Safety Recall Trucks

Date	Group.	No.	Page
11.12	SC0365		1(9)

Forward Lighting Operation
CHU, CXU

Retrofitted Harness Connection

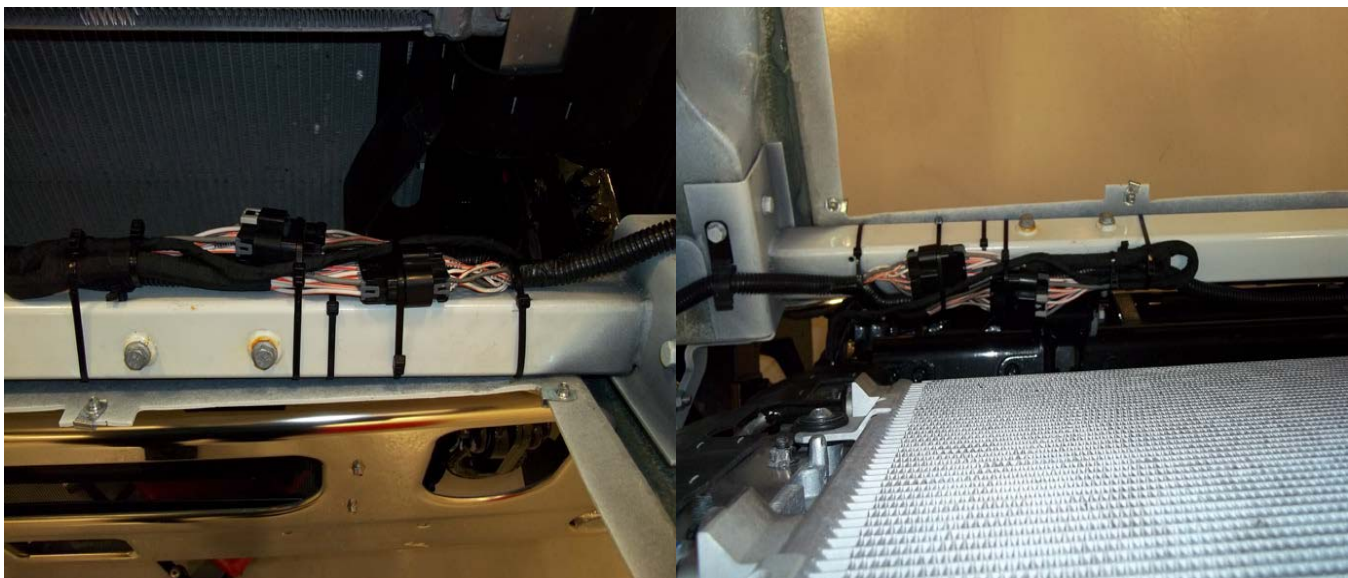
6. *** This step applies to MACK CXU vehicles only.
 - A. On the horizontal crossbar, connect the overlay harness to the head light harness connector. Secure the connector and harness with cable ties.
 - B. Remove the p-clip and bolt securing the hood harness from the vertical portion of the hood (stand-off bracket).
 - C. Route the hood harness under the stand-off bracket, overlay harness and connector above the stand-off bracket. Secure the connector and harness with cable ties.

- 1. P-Clip Removed
- 2. Front Chassis Harness Connection
- 3. Overlay Harness (Part Number 22012391)
- 4. Hood Harness Connection
